Canoga Transportation Corridor

Final Environmental Impact Report Addendum

December 15, 2008

Revised Figure 4.10-2

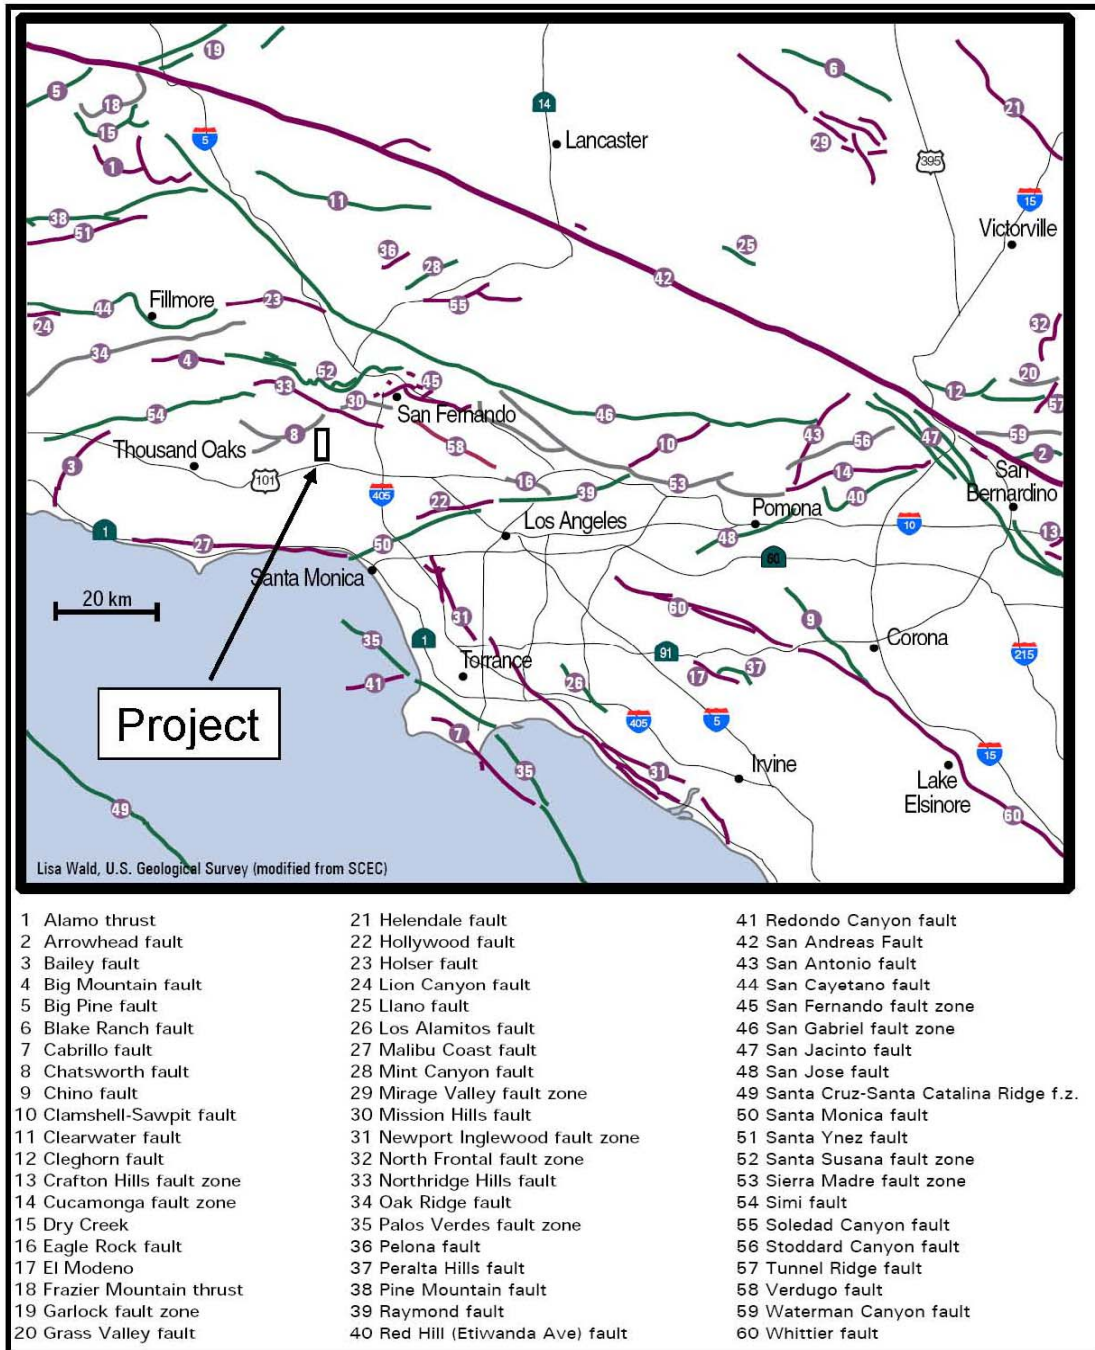
Page 4.10-7, Figure 4.10-2, is revised as shown on the following page.
